Product Bulletin

Promix LCD Hydraulic Pump Selection Jumpers 190403-1

Bulletin Date:	03/04/19
Hardware Topic :	Changes to Promix LCD Main PCB
Hardware Details:	Jumpers added for Electronic Hydraulic Pump Selection

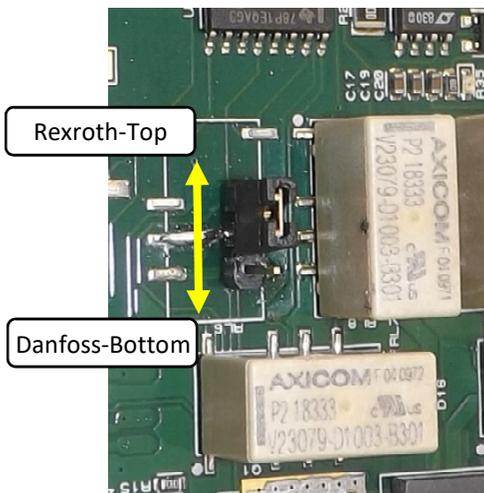
Electronic Hydraulic Pump Selection must now be made with both the on-screen menu and two physical jumpers on the PCB.

See picture to the left for jumper locations.

For Rexroth, both jumpers must be in the TOP position.

For Danfoss, both jumpers must be in the BOTTOM position.

Please see picture to the left for clarification of TOP and BOTTOM.

Factory default settings are Danfoss

IMPORTANT! NO OTHER JUMPER POSITION COMBINATIONS ARE ALLOWED.
